UNITED STATES PATENT AND TRADEMARK OFFICE

APPLICATION NO.	FILING DATE	FIRST NAMED INVENTOR	ATTORNEY DOCKET NO.	CONFIRMATION NO.
10/776,870	02/11/2004	Juri Heinrich Krieger	H2016CIP	3885

Office Action Summary	Application No. 10/776,870	Applicant(s) KRIEGER ET AL.	
	Examiner TRONG PHAN	Art Unit 2827

Fig. 6a

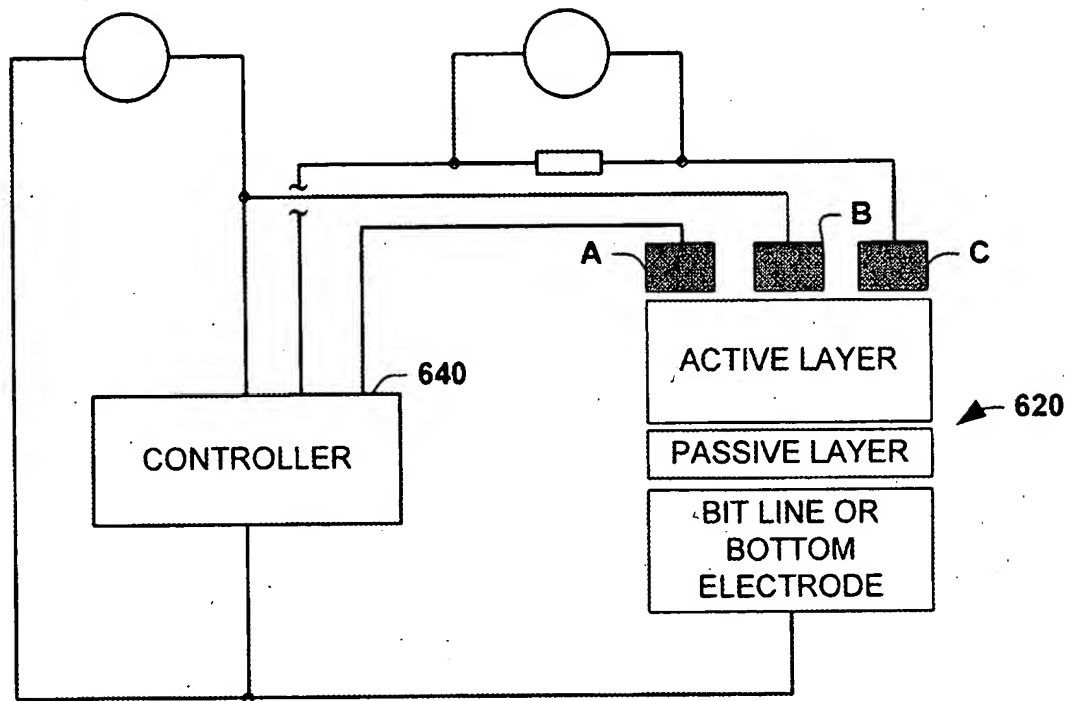
3. The drawings are objected to because the current I in the vertical axis of Fig. 6 having m units (-8.0m, -4.0m, 0.0m, 4.0m and 8.0m) not ampere (A) as conventional. Corrected drawing sheets in compliance with 37 CFR 1.121(d) are required in reply to the Office action to avoid abandonment of the application. Any amended replacement drawing sheet should include all of the figures appearing on the immediate prior version of the sheet, even if only one figure is being amended. The figure or figure number of an amended drawing should not be labeled as "amended." If a drawing figure is to be canceled, the appropriate figure must be removed from the replacement sheet, and where necessary, the remaining figures must be renumbered and appropriate changes made to the brief description of the several views of the drawings for consistency. Additional replacement sheets may be necessary to show the renumbering of the
